ARMENIAN CHURCH AND CULTURAL CENTER JSP25-0031

Public Hearing at the request of Armenian Cultural Center of Greater Detroit, Inc. for approval of Special Land Use, Preliminary Site Plan, Phasing Plan, Wetland Permit, Woodland Use Permit, and Stormwater Management Plan. The subject property is located at 41100 Twelve Mile Road (Section 12). The applicant proposes phased construction of a church and accessory cultural center uses including a day care center.

REVIEW	RESULT	DATE	COMMENTS
Planning	Approval Recommended	06/30/26	• Special Land Use for place of worship in RA: Residential Acreage District • Special Land Use for daycare in RA: Residential Acreage District • Phasing Plan Approval • Zoning Board of Appeals (ZBA) variance required under Section 3.1.1.D and Section 4.10.5 for the monument height of 62.83 ft • ZBA variance required under Section 4.19.2F for the dumpsters to be located in the side yards • Items to be addressed at Final Site Plan submittal
Engineering	Approval Recommended	12/11/25	• Items to be addressed at Final Site Plan submittal
Landscape	Approval Not Recommended	06/12/26	• Landscape waiver under Section 5.5.3.A.v for deficiency in screening berms (supported

Sheet No.
A-9.1

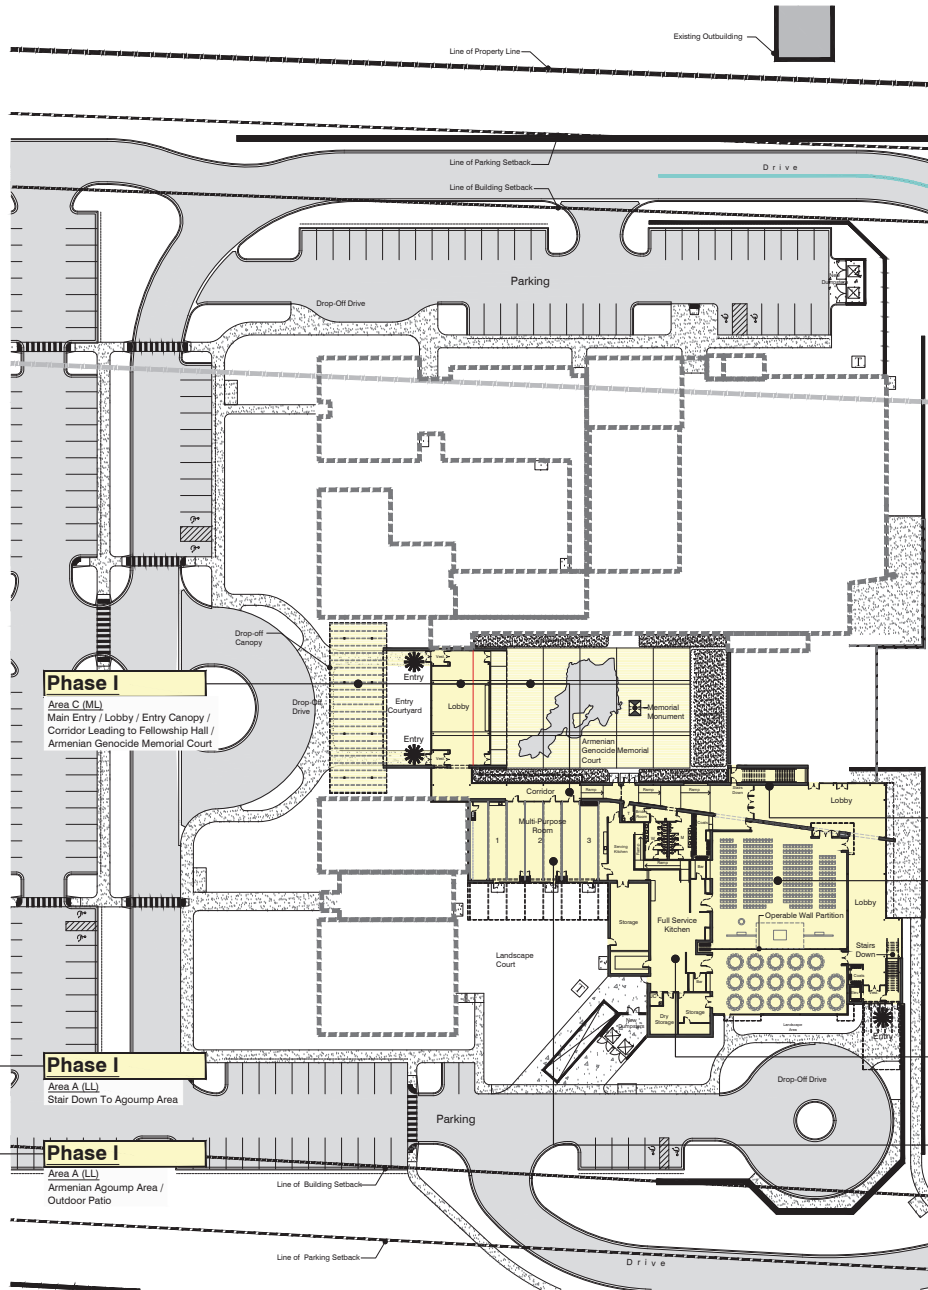
1. Phasing: **See attached Sheet A-9.1 for separate Site Plan highlighting Phase 1 Construction.**
2. Building Height: **Noted. We will be submitting for a variance.**
3. Noise Impact Statement: **Any sound generated by the six Picnics and festival shall not exceed those decibel levels indicated in Section 5.14.10.A.ii “Weighted Sound Level Limit Decibels” for Zoning Districts abutting the subject property. These anticipated maximum decibel levels (not to exceed) are 55 dB during night-time hours, and 60 dB during day-time hours. To control any sound generated from these proposed activities, any performing band shall be positioned to direct sound toward Twelve Mile Road, away from any adjoining residence.**

rPSP: Resolved – Phase 1 construction is shown on Sheet A-9.1.

See attached Sheet A-9.1 for separate Site Plan highlighting Phase 1 Construction.

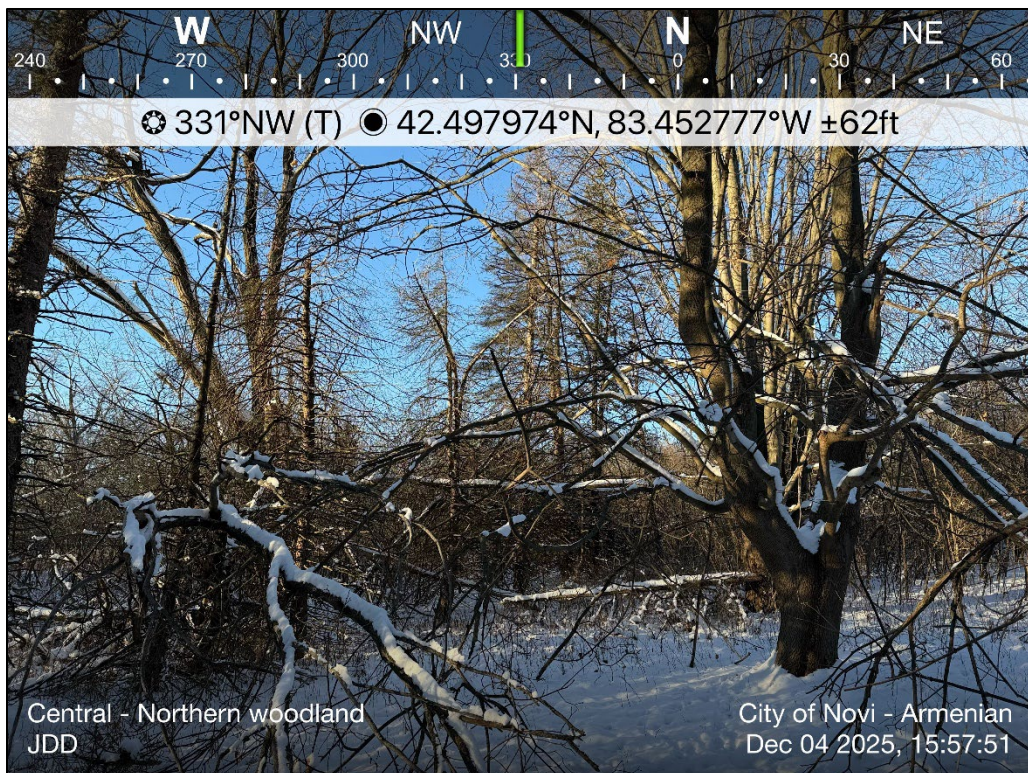
Captured approximately near Tree 460, this maple was measured to be 42-inches DBH. No trees in the tree survey (excluding the large willows) were measured with this large of DBH. No tree tags or identifiers present.

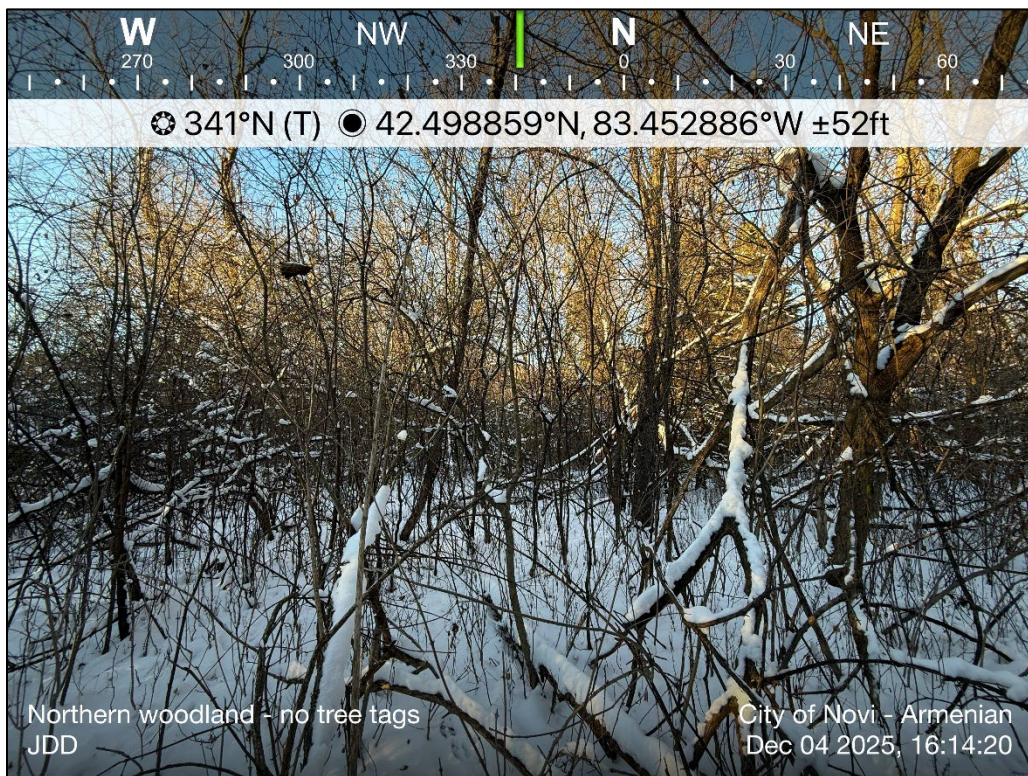
Some Norway spruce (*Picea abies*, foreground) trees on-site may have been misidentified as Colorado blue spruce trees (*Picea pungens*).

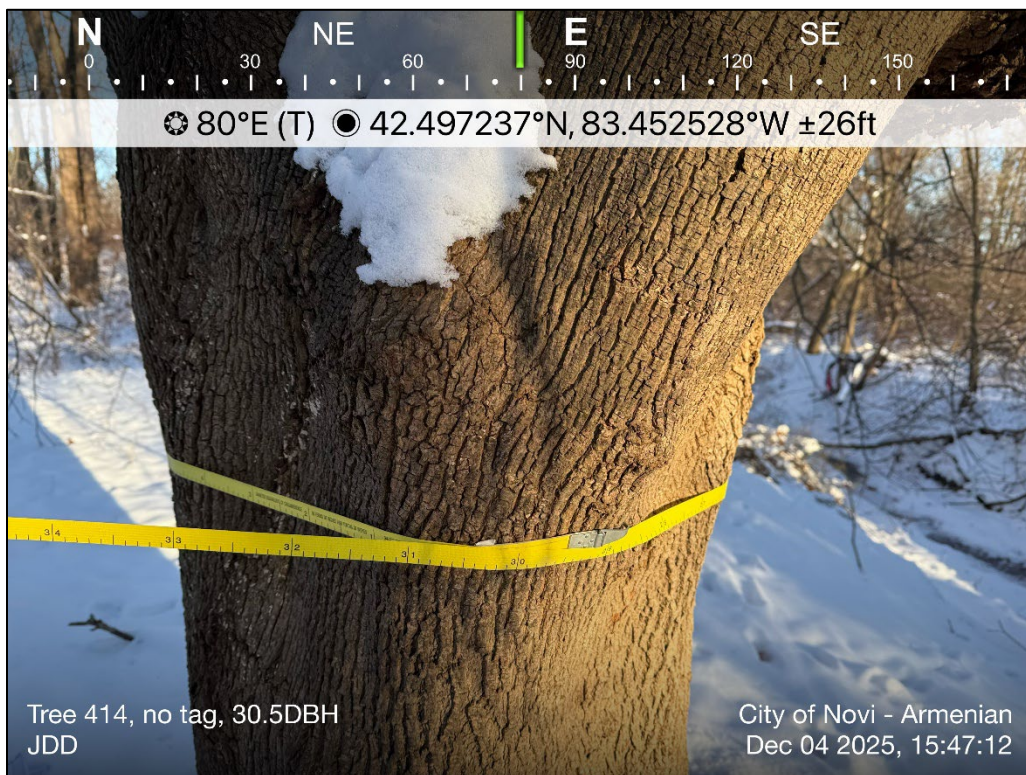
Likely Tree 389 (no identification present on-site), which was identified as having a DBH of 30-inches was measured to have a DBH of 40-inches on-site.

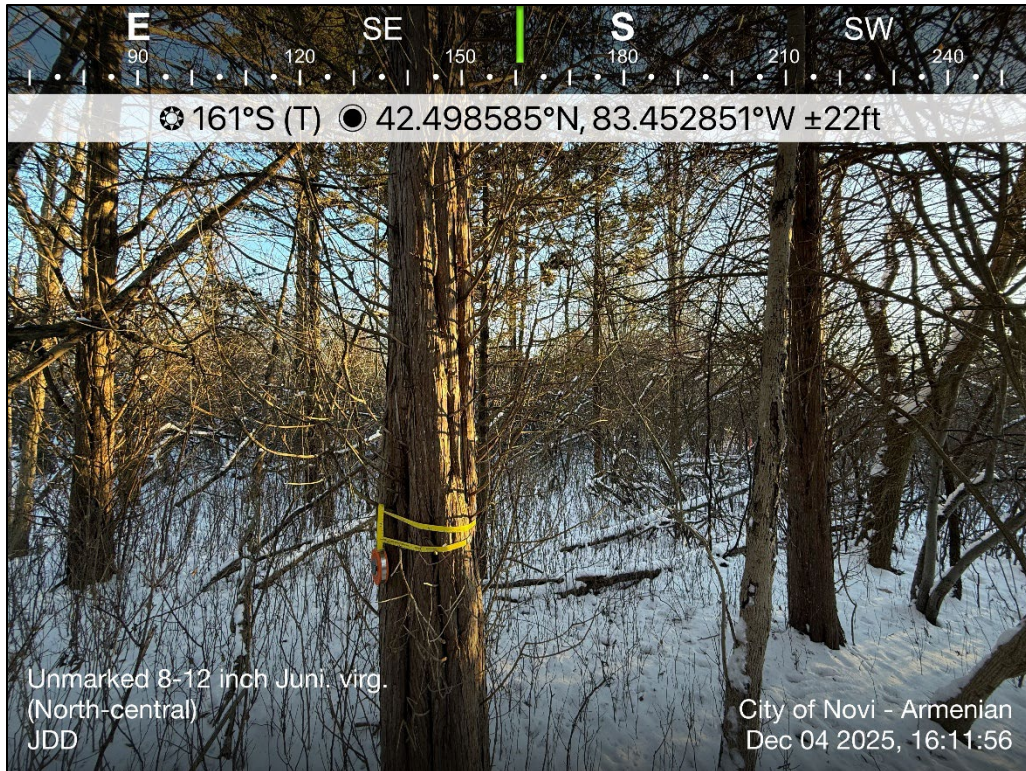
Likely Tree 414 (no identification present on-site), which was identified as having a DBH of 24-inches was measured to have a DBH of 30.5 (31)-inches on-site.

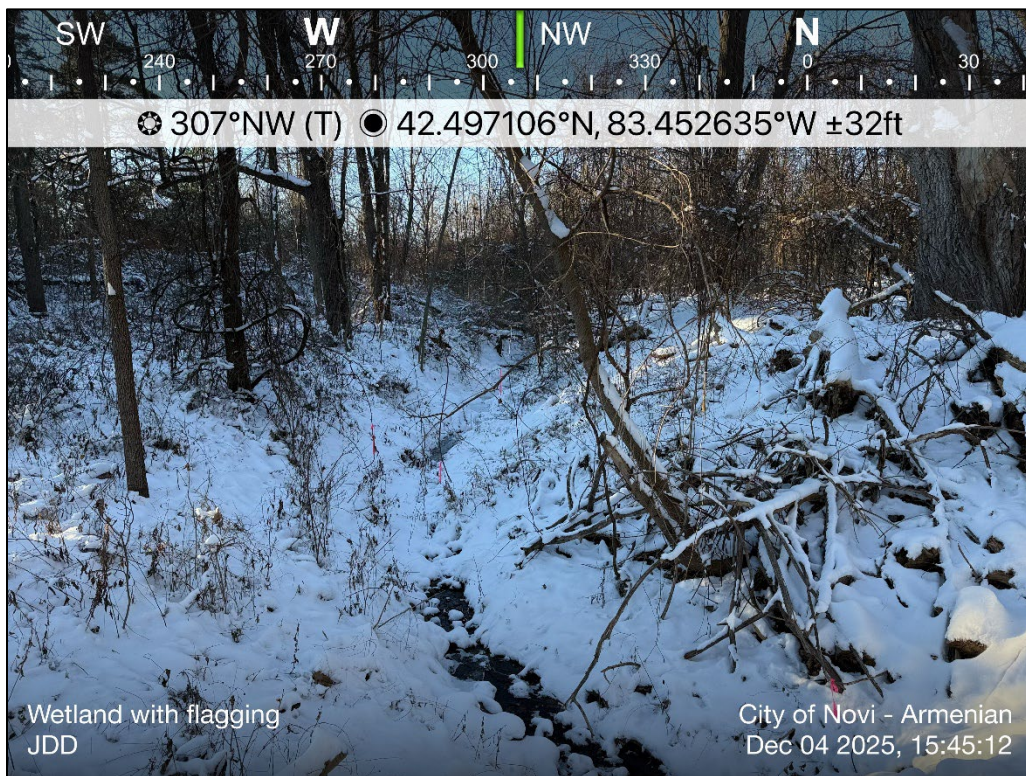
A large stand of unmarked 8-12 inch DBH eastern red cedar (*Juniperus virginiana*) trees in the north-central portion of the site.
